General machining tolerances UNI 5307-63								
Dimensions	< 6	>6-30	>30-120	>120-315	>315-1000	>1000-2000	>2000-4000	>4000
linear Toll.	± 0.1	± 0.2	± 0.3	± 0.5	± 0.8	± 1.2	± 2	± 3
angular Toll.	± 1	± 30'	± 20'	± 10' referred to the shortest side				
				designed for <b>R.De Salvo</b>				
				draw. by <b>G. Gennaro-PROMECC</b>				
title <b>HAM-OPTICAL BENCH</b> <b>BALLAST</b>				date 26-10-05		scale 1/2.5		
				LIGO-D051175-04-D				
				detail from 103-176		A 3

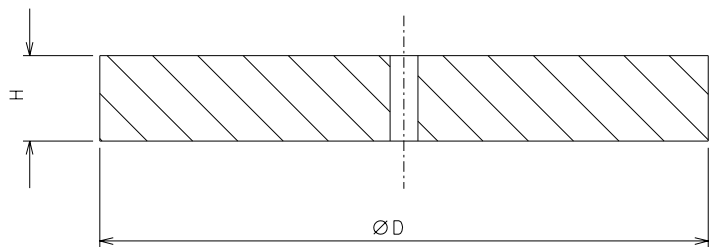
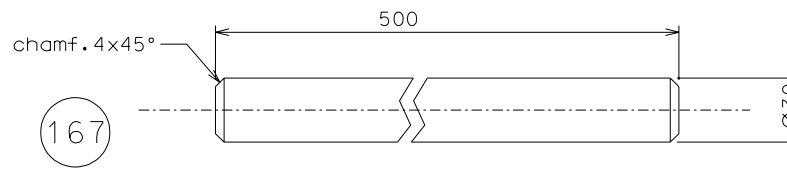
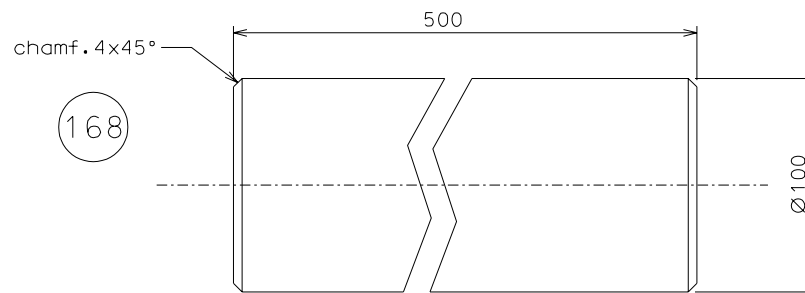
166 flame cut OK

modified part 166 as built	19-07-06				
		modified n° parts detail 166	08-04-06				
		modified ref. assembly	26-02-06				
ref.		note	date	signature			
modifications							
168	17	inox	1/2.5				
167	16	inox	1/2.5				
166	13	Fe 340	1/2.5				
ref.	pieces	mat. and treatments	scale	ref.	pieces	mat. and treatments	scale
